APPLICATION NO.	FILING DATE	FIRST NAMED INVENTOR	ATTORNEY DOCKET NO.	CONFIRMATION NO.
10/816,697	04/05/2004	Richard Scott Bourgeois	126533-1	9731

Office Action Summary	Application No. 10/816,697	Applicant(s) BOURGEOIS ET AL.	
	Examiner Tony Chuo	Art Unit 1795

DETAILED ACTION

FIG. 1

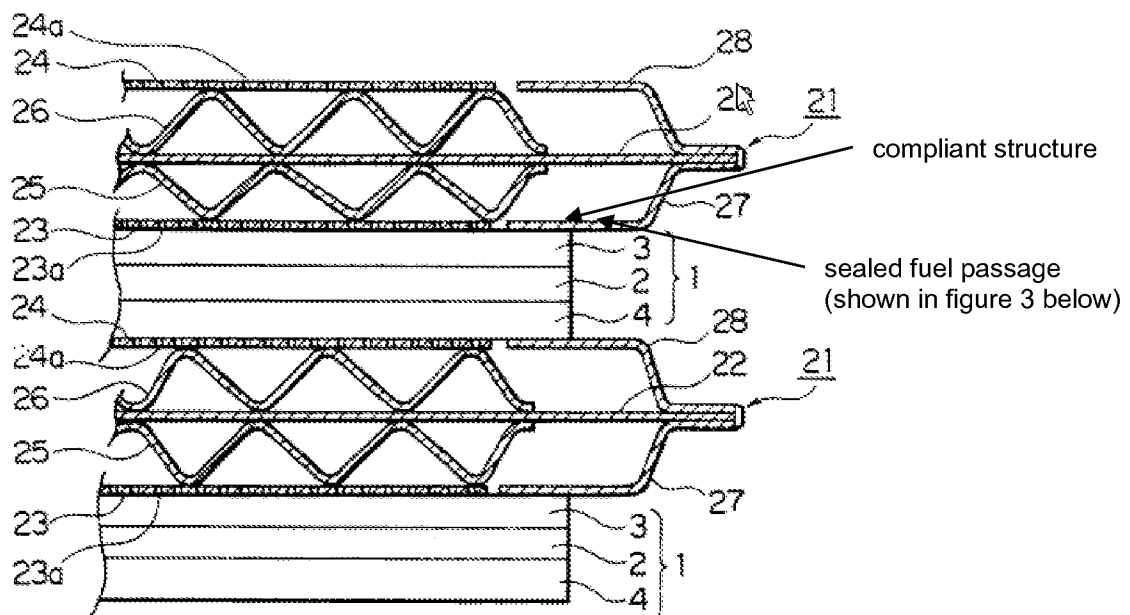
Regarding claim 19 and 34, the Sasaki reference discloses a fuel cell stack comprising: a first fuel cell assembly “1” & “21” and a second fuel cell assembly “1” & “21” electrically coupled together such that sealed manifolds extend between the first and second fuel cell assemblies, each first and second fuel cell assembly comprising: a hollow manifold comprising a top wall “22” and a bottom wall “23” & “27”, wherein each of the top and bottom walls include a sealed fuel passage for allowing fuel to enter and

exit the hollow manifold; and a fuel cell “1” comprising an anode “3”, a cathode “2”, and an electrolyte “4” disposed there between, wherein the fuel cell “1” is disposed on the bottom wall “23” & “27” between the at least one manifold, wherein the bottom wall “23” & “27” of the at least one hollow manifold extending between the fuel cell and the sealed fuel passage includes thin plates “27” that are rich with flexibility to accommodate strain therebetween (See Figures 1 and 3, column 5 line 40 to column 6 lines 9-16, and column 7, lines 3-11).

Examiner’s note: The Sasaki reference discloses gas inlet manifold and gas outlet manifold (not shown in Figure 1), located left and right of the fuel cell, are construed as being sealed fuel passages (See Figures 1 and 3 and column 7, lines 3-11). Therefore, the thin plates “27” are located adjacent to the fuel cell and the sealed passage.

Regarding claim 20, it also discloses a cathode flow channel coupled to the hollow manifold of the first fuel cell assembly and the second fuel cell assembly that is configured for directing an oxidant between the first fuel cell assembly and the second fuel cell assembly (See Figure 1).

Regarding claim 21, it also discloses a hollow manifold that is substantially rectangular (See Figure 1).

Regarding claims 32 and 33, it also disclose the top wall "22" and bottom wall "23" of the hollow manifold that act as an anode interconnect (See Figure 1).
